Re: Permit No. M-1980-244; Cripple Creek & Victor Gold Mining Company; Cresson Project; Adequacy Review Response to Technical Revision 128 – Ironclad Facilities Access Road Re-Alignment

**ATTACHMENT 1:
PROPOSED ACCESS ROAD & NON-
JURISDICTIONAL WETLANDS MAP**

Proposed Access Road & Non-Jurisdictional
Wetlands Map

**ATTACHMENT 2:
GM06 STOCKPILE & PROPOSED ACCESS
ROAD FIGURES**

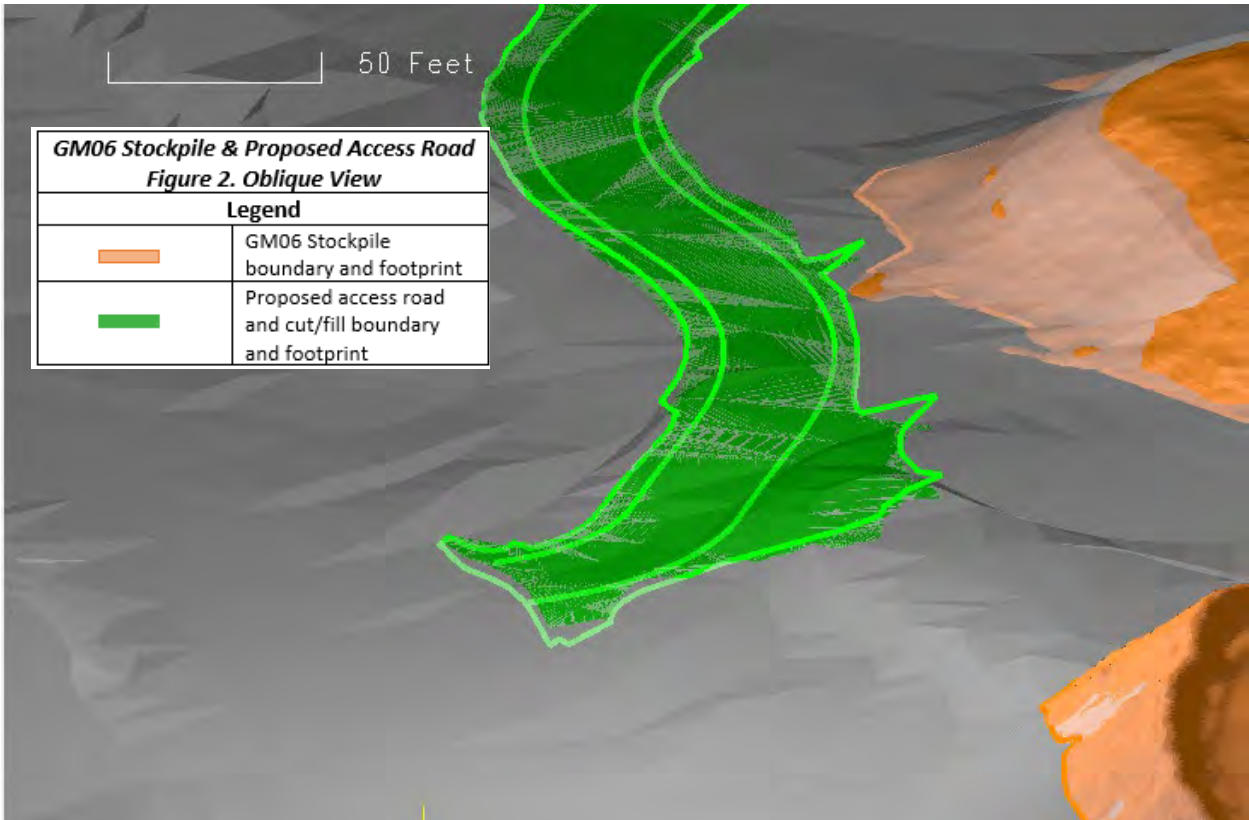
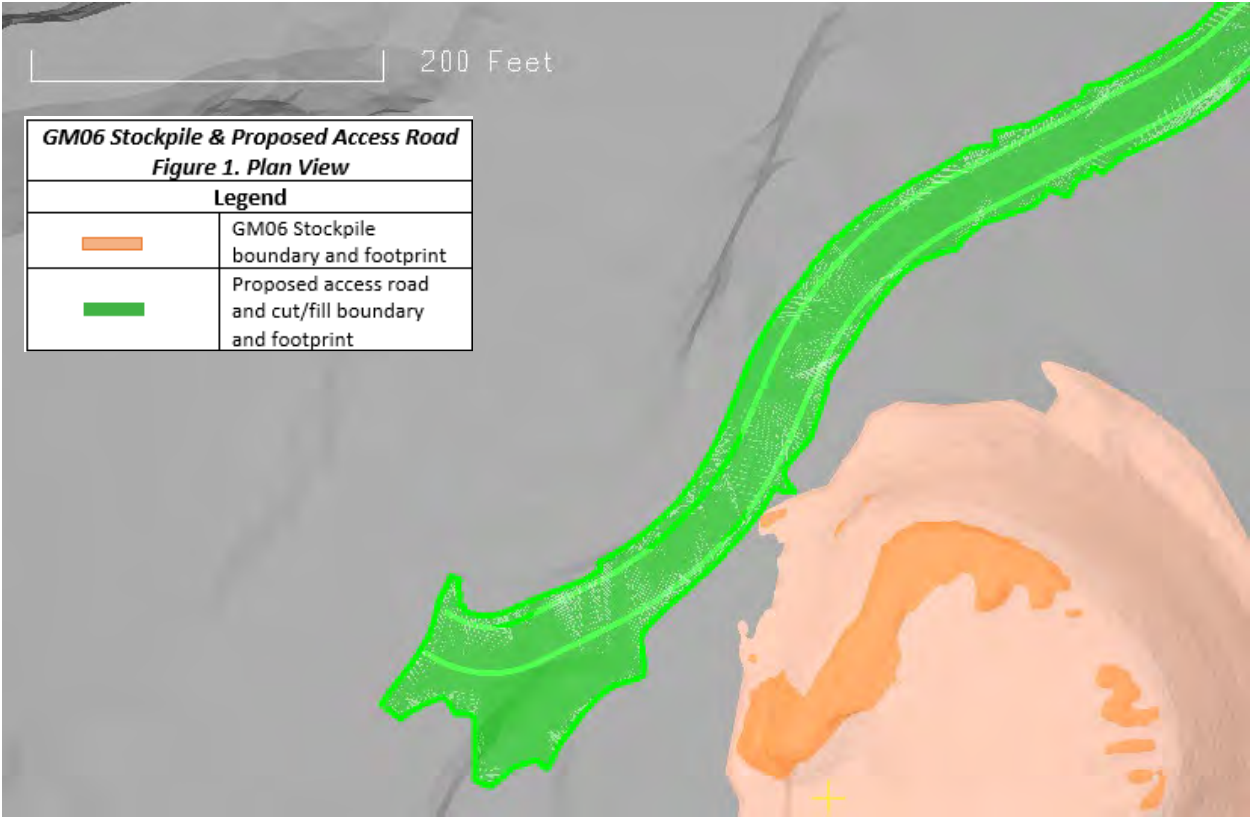
2. Drawing A14 appears to depict material from Growth Medium Storage Area 6 which will need to be cut to facilitate the construction of the access road. Please confirm if this material is growth medium and if it is, please address the following:

- a. Please provide the approximate amount of material that will be removed. Please confirm this quantity is not included in the 24,500 CY calculation of cut material that will be used as fill for the access road construction.
- b. Discuss how the growth media will be handled and where it will be placed.

GM06 is not anticipated to intersect the access road footprint of the proposed access road. Figures 1 & 2 in Attachment 2 depict the spatial relationship between GM06 and the access road footprint. In the event growth media from GM06 is encountered during construction, material will be removed, placed back onto the GM06 stockpile, graded, and seeded for stabilization purposes.

Figure 1. Overview of the proposed access road, geotechnical cross section locations shown with access road design stations for reference. CR-82 rout shown in magenta.

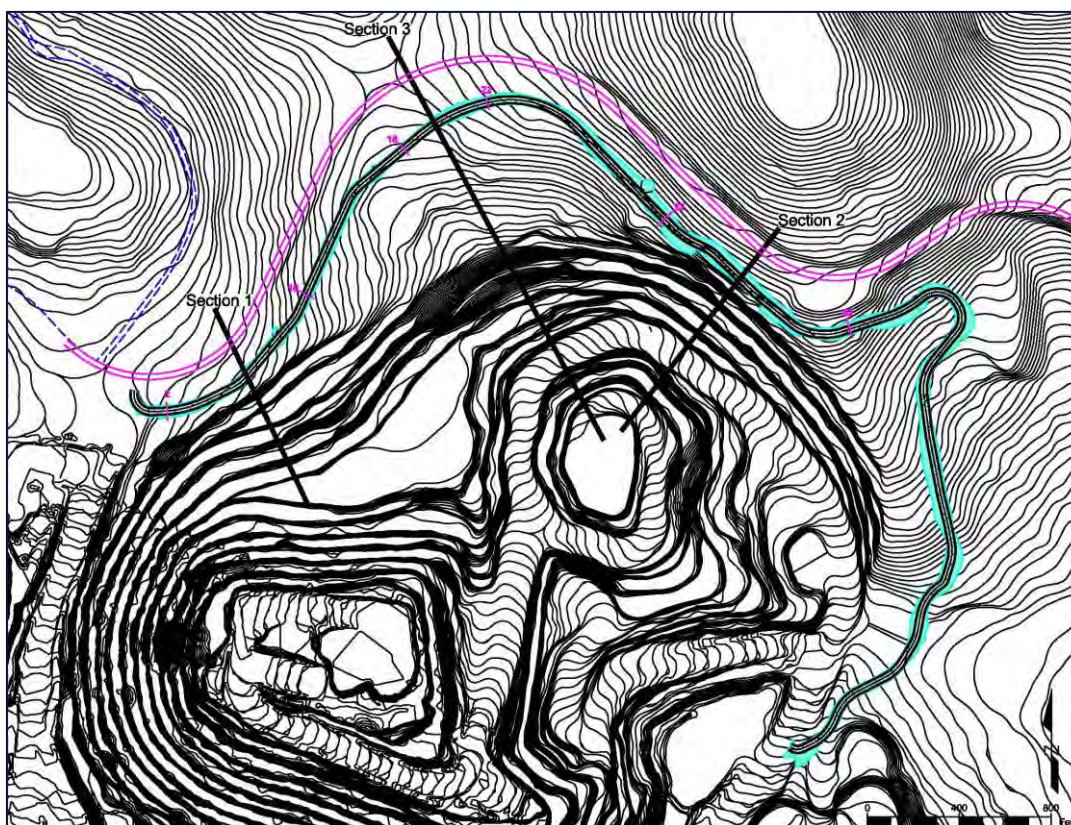
- 9. Please submit a geotechnical stability analysis showing the addition of the road along the crest of the WHEX Pit highwalls does not affect the stability of the highwalls. The analysis will need to specifically cover the portions of the road from Station 2+00 to 10+00 and 32+00 to 42+00. The analyses should account for two simultaneously passing semi-trucks (H-20 loading) within these designated sections of the proposed road.**

A Stability Analysis has been performed for the Proposed Access Road. Findings from this analysis, including details requested on the October 8, 2021 conference with DRMS, are summarized in Memo EG21-11 in Attachment 4.

The cross sections for analysis were drawn based on requests by DRMS; Section 1 is between stations 2 and 10, Section 2 is between stations 32 and 42, and Section 3 is between stations 18 and 22. The analysis included modeling loaded traffic that would be expected on that road to see what effect there might be on the stability of the road or highwalls below. The properties of the materials used in the analysis and the loading are summarized in Table 1.
